April 5, 2000

To: jdichoso@fcc.gov
FCC Application Processing Branch
Re: FCC ID EO9PET
Applicant: Itron Inc
Correspondence Reference Number: 13030
731 Confirmation Number: EA95767
Date of Original E-Mail: 03/27/2000

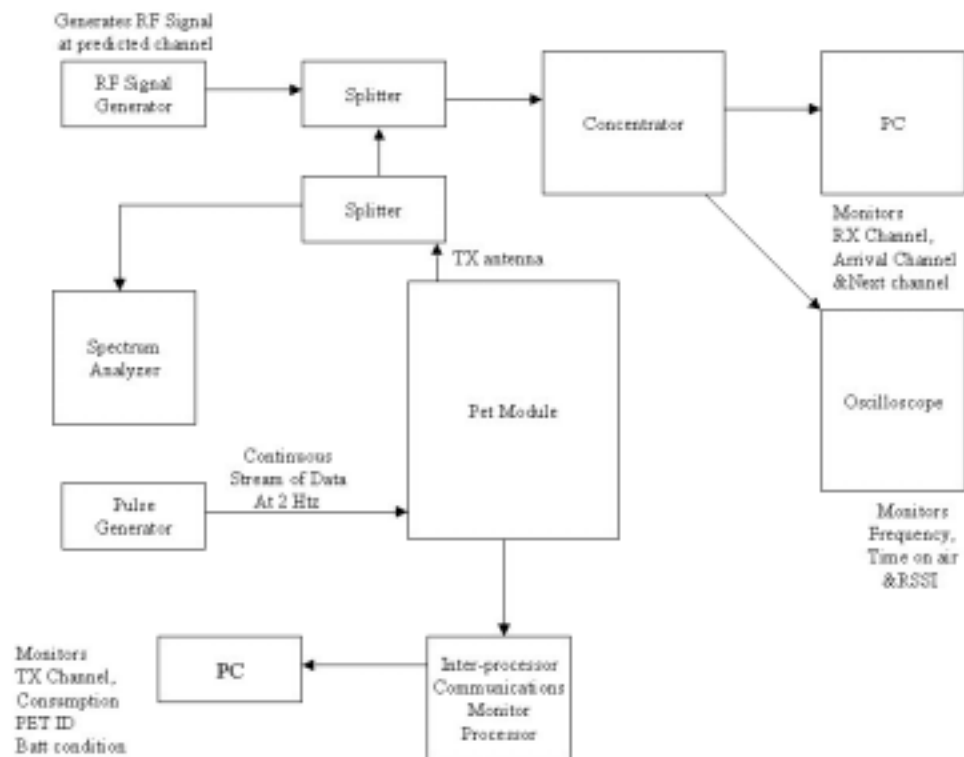
We have implemented the suggested test plan submitted to you for approval on March 28. The equipment was set up as shown in the block diagram provided on the following page. The PET transmitter was fed a continuous data input and we were able to accurately monitor the actions of the transmitter and receiver with test equipment and to document the specific channel activity with the PC's. We have a lot of supporting data should you be interested in any additional detailed data.

We confirmed that both transmitters used each frequency equally on the average. The transmitter stepped through all of the 25 pseudo randomly ordered channels before reusing a frequency. A maximum length data packet (138 ms) was transmitted on each channel. We confirmed this with the spectrum analyzer by looking at each anticipated frequency as the transmitter hopped channels. We also compared the new hop table list of the hop frequencies and channels assigned to each of the 2 serial numbers for conformity with the frequencies actually observed with the two transmitters tested. We monitored and documented the transmitter channel, consumption, PET ID and battery condition.

We also confirmed that the receiver tracked the transmitter accurately stepping to the next anticipated channel based on the transmitters hop table, just ahead of the transmitter. We monitored the receive channel, arrival channel and next channel with the PC.
